UNITED STATES PATENT AND TRADEMARK OFFICE

APPLICATION NO.	FILING DATE	FIRST NAMED INVENTOR	ATTORNEY DOCKET NO.	CONFIRMATION NO.
10/520,995	01/11/2005	Graham John McLeish		5217

Office Action Summary	Application No. 10/520,995	Applicant(s) MCLEISH, GRAHAM JOHN	
	Examiner James R. Harvey	Art Unit 2833

DETAILED ACTION

DETAIL FROM X

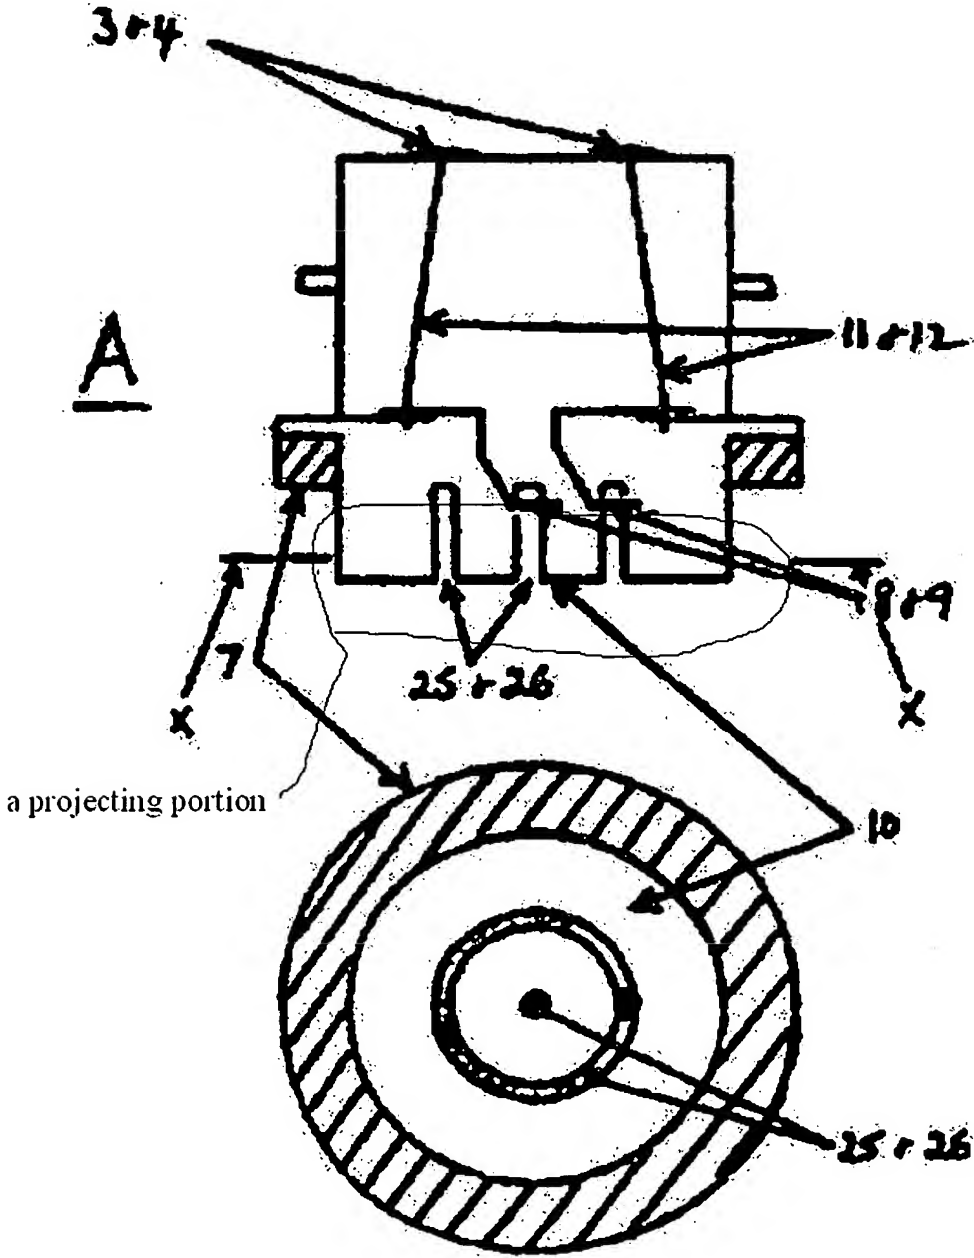
-- In reference to Claim(s) 2 and 8, Brazier shows the female part has a projecting portion (see examiner's figure) which is adapted to be received within the male part.

-- In reference to Claim(s) 10, Brazier does not explicitly show the projecting portion is adapted to have a degree of freedom to pivot within the male part.

Degrees of freedom, in there broadest sense, are dependent upon size.

It would have been obvious to one of ordinary skill in the art at the time the invention was made to change the size of the male and female parts of Brazier in order to adapt them for a degree of freedom, since such a modification would have involved a mere change in the size of a component. A change in size is generally recognized as being within the level of ordinary skill in the art. In re Rose, 105 USPQ 237 (CCPA 1955).

One skilled in the art would have been motivated to change the size in order to allow for a possible difference in the coefficient of thermal expansion between the male and female parts.

(10) Pub. No.: **US 2002/0086559 A1**

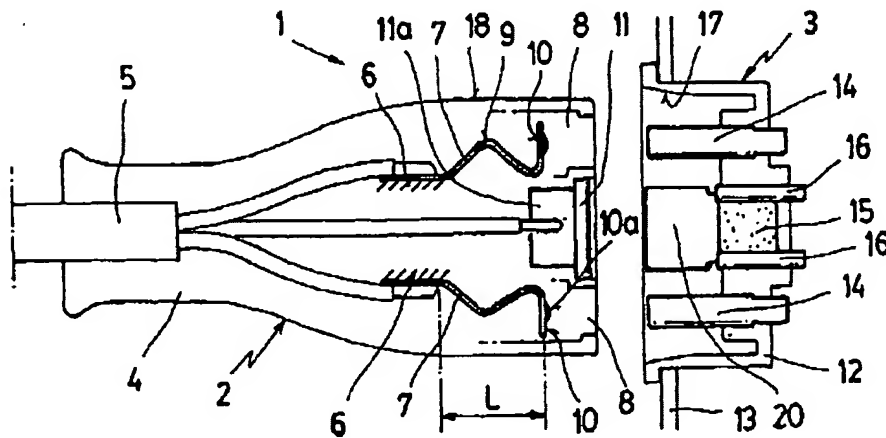
-- In reference to Claim(s) 16, Brazier shows substantially the invention as claimed. However, Brazier does not discuss the benefits of an earth terminal.

Delmau teaches that magnetic means can be used with three-prong connectors.

It would have been obvious to one of ordinary skill in the art at the time the invention was made to add an additional terminal, since it has been held that mere duplication of the essential working parts of a device involves only routine skill in the art. St. Regis Paper Co. v. Bemis Co., 193 USPQ 8 .

One skilled in the art would have been motivated add an earth terminal in order to make the connector of Brazier marketable to organization that are required to meet the safety standards associated with a three prong connector.
